MADISON 2ND ADDITION

Re: S/D 98-71 -- One-Step Final Plat of MADISON 2ND ADDITION

S/D 98-71 - One-Step Final Plat of MADISON 2ND ADDITION

CASE NUMBER: S/D 98-71 - MADISON 2ND ADDITION

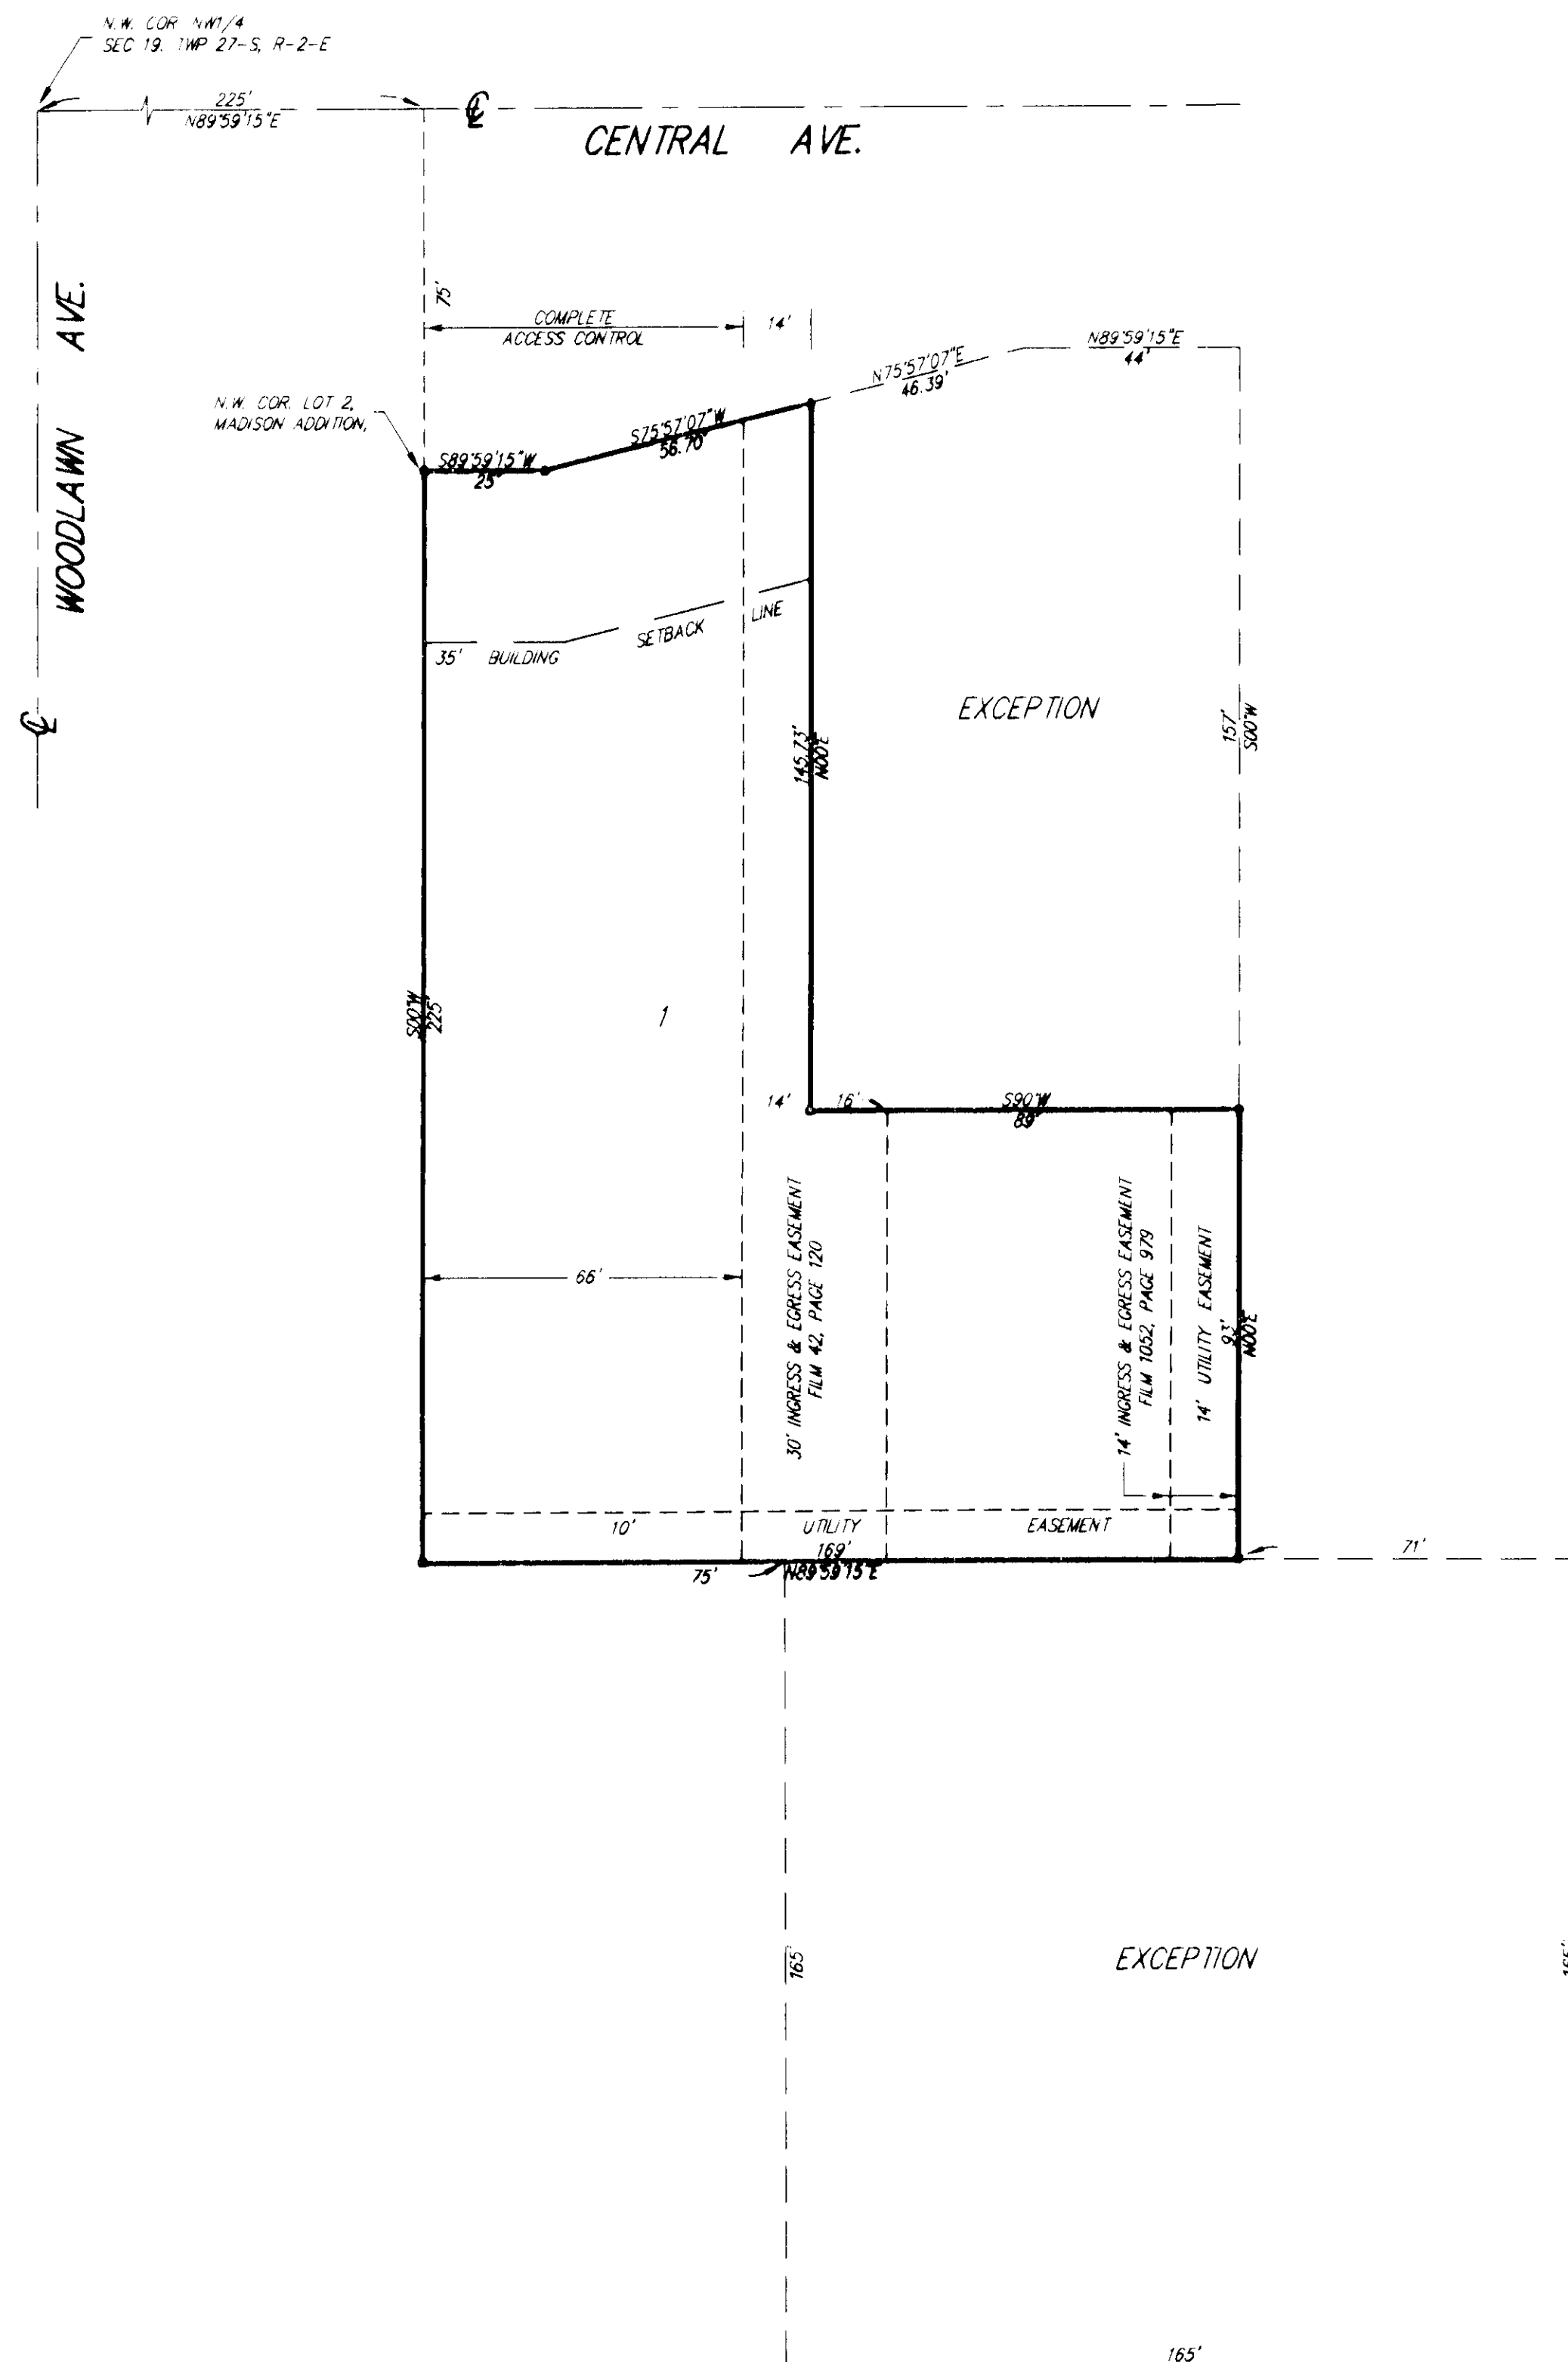
- C. City Engineering needs to comment on the status of the applicant's drainage plan.
- D. Sufficient access is provided through the shared opening with the plat to the east. The Applicant shall submit to MAPD the joint access easement.

- G. The legal description must be revised to correspond with the land being platted. The bearings for the east-west line between the plat and the exception area should be identical to those in the legal description.

KG&E has requested additional easements.
